**PN 19-151786 / AHWC 1<sup>st</sup> Consolidate Metabolic Kitchens on Campus**

**Notice Number: 19-151786**

**ADDENDUM 1**

**CU ANSCHUTZ - AHCW METABOLIC KITCHEN**

**PARTIAL LEVEL 1 HVAC PLAN**  
SCALE: 1/8"=1'-0"

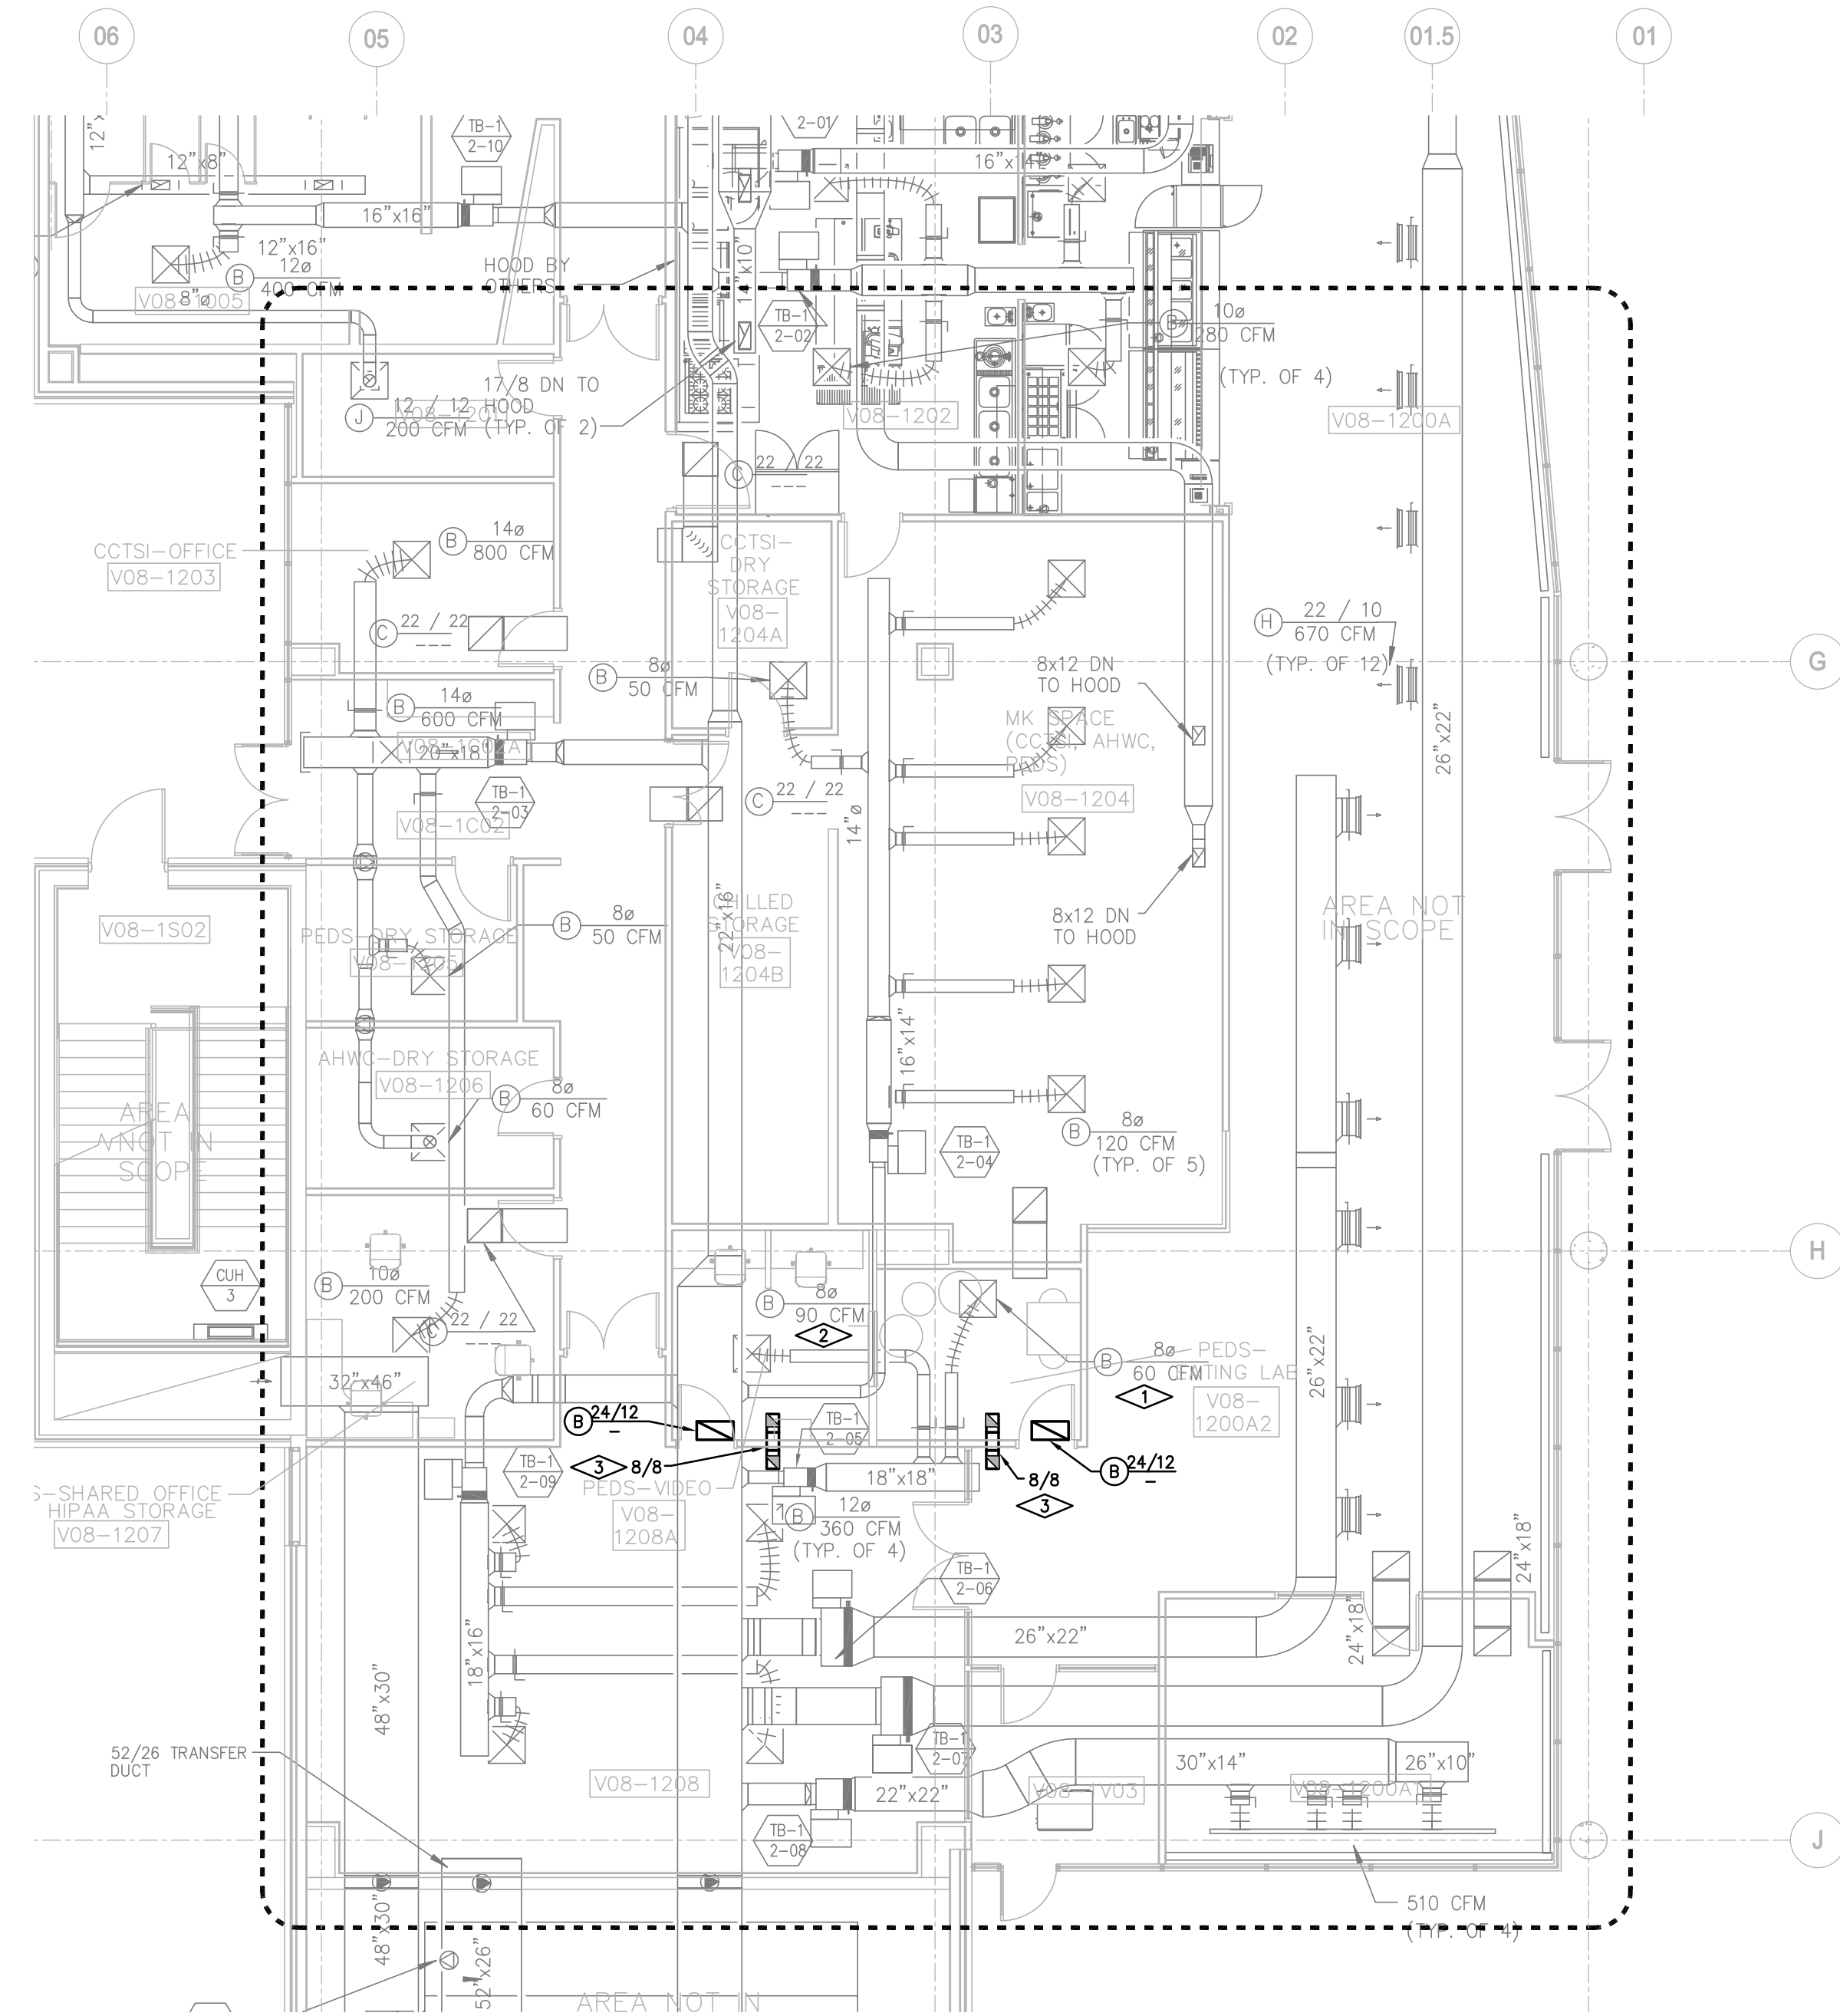
1. M-101: Refer to Addendum 1 revision on attached sheet.

**NEW KEY NOTES:**

1. BALANCE AIR QUANTITY OF EXISTING AIR DEVICE TO 110 CFM.
2. BALANCE AIR QUANTITY OF EXISTING AIR DEVICE TO 120 CFM.
3. TRANSFER DUCT TO BE INSTALLED ABOVE CEILING (I.E. IN PLENUM SPACE).
4. RIGID SHEET METAL DUCT SHALL BE USED FOR PENETRATION OF WALL. FINAL CONNECTION TO AIR DEVICE VIA FLEXIBLE DUCT.
